Subject: **Docket No. 50-361**  
**Response to Request for Additional Information (RAI 25)**  
**Regarding Confirmatory Action Letter Response**  
**(TAC No. ME 9727)**  
**San Onofre Nuclear Generating Station, Unit 2**

**Response to RAI 25  
(NON-PROPRIETARY)**

## RAI 25

Figure 1. Tubesheet Map of Dings => 0.5 volts, SG 2E-089, PSI Inspection

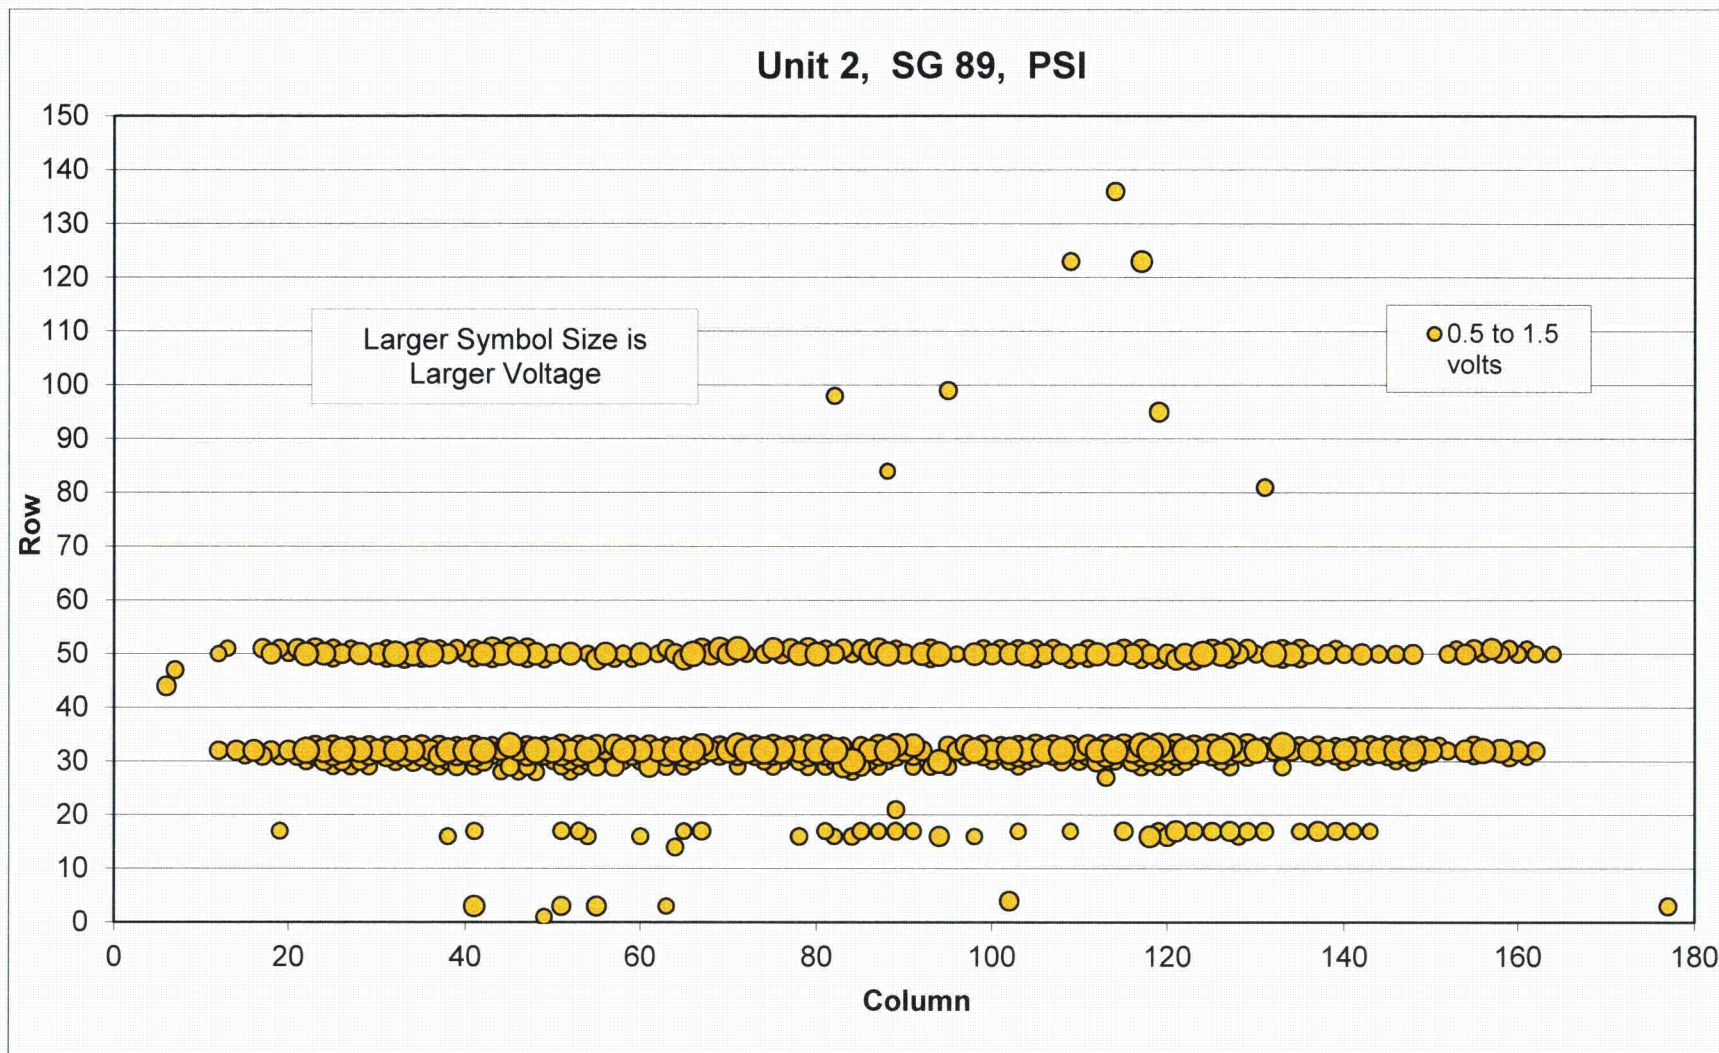
Reference 3, page 59 of 129 -There is a statement in the last paragraph that reads, "Patterns of dents and associated high contact forces are in good agreement with the final quarter model calculations." Provide or show this comparison.

Figures 1 and 2 (corresponding to Figure 6-19 and 6-20 in RAI Reference 3) show tubesheet maps of dings equal to or greater than 0.5 volts at the PSI inspections of SG 2E-089 and SG 3E-089 respectively. These dings are associated with contact forces of [ ] and higher. There are more dings in SG 2E-089 compared to SG 3E-089 by a factor of about 13. Figures 1 and 2 show that dings occur primarily in rows. These rows correspond to the noses of AVB pairs. See Figure 3 which is the same as Figure 3-1 of RAI Reference 3. There are sporadic dings in high rows near the periphery. The row pattern is much more distinct in SG 2E-089 simply because there are many more dings in SG 2E-089.

Figures 4 and 5 plot tube sheet maps of calculated contact forces equal to or greater than [ ] in the cold condition corresponding to the PSI results. A comparison of Figures 1 and 2 with Figures 4 and 5 shows that observed ding locations compare very well with FEA calculations of where dings should be observed.
